VERIFICATION REPORT OF LAS PIZARRAS PROJECT

Project Title	<i>Las Pizarras Project</i>
Version	<i>02</i>
Report ID	<i>2014/144/VOL/29</i>

Report Title	<i>VCS Verification report of the project activity: Las Pizarras Project</i>
Client	<i>Empresa Eléctrica Río Doble S.A.</i>
Pages	<i>59</i>
Date of Issue	<i>04-March-2016</i>
Prepared By	<i>Spanish Association for Standardisation and Certification (AENOR)</i>
Contact	<i>6 Génova. 28004 Madrid – Spain. Telephone +34 914326000 Fax +34 913190581. lrobles@enor.es, www.aenor.es</i>
Approved By	<i>Luis Robles Olmos, Manager of Climate Change Unit</i>
Work Carried Out By	<i>Team Leader: Freddy Alejandro Garro Flores Verifier: Marcelino Pellitero Martínez Technical Reviewer: Luis Javier Arribas Alonso</i>

Deviation 1: Remove redundant meters and implement a more simply and realistic system

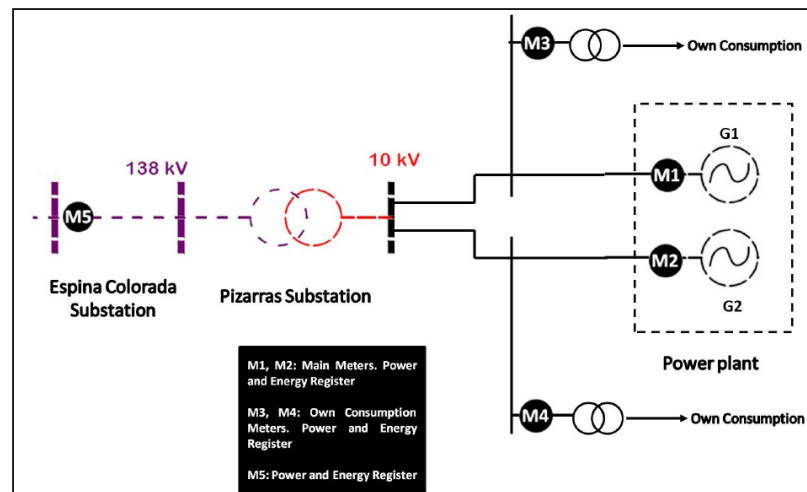
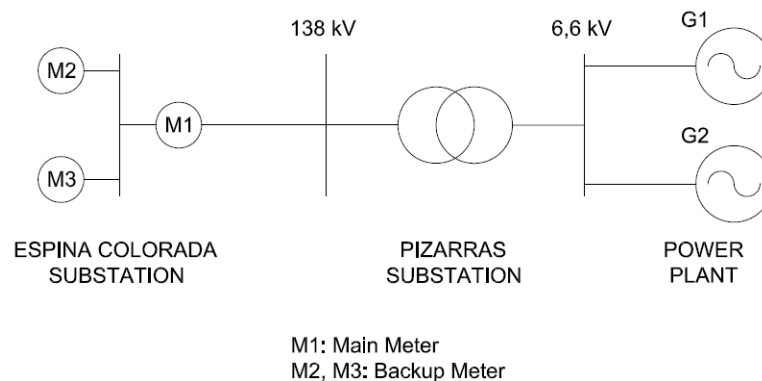
During the verification process the audit team identified that the tentative location of electricity meters stated in the registered CDM-PDD is not in accordance with the current electricity meters installed in the project activity. The registered CDM-PDD indicates following figure:

According to the monitoring report the PP has made the following change of the location of the energy meters in the monitoring plan:

AENOR team requested project participants to provide information in order to explain this deviation. According to the PP, the tentative Meters M1 and M2 (main meters) are redundant, so these have been unified at current M1. In the other hand, tentative M4 and M3 are not considered useful since the current meters are bidirectional, and these measure the value of net electricity to the grid. M5 has been substitute by two backup meters: M2 and M3. According to this explanation the DOE has verified that the deviation to the registered monitoring plan described in the monitoring report, is in compliance with the applied methodology and do not reduce the level of accuracy of the monitoring compared with the requirements contained in the registered monitoring plan.
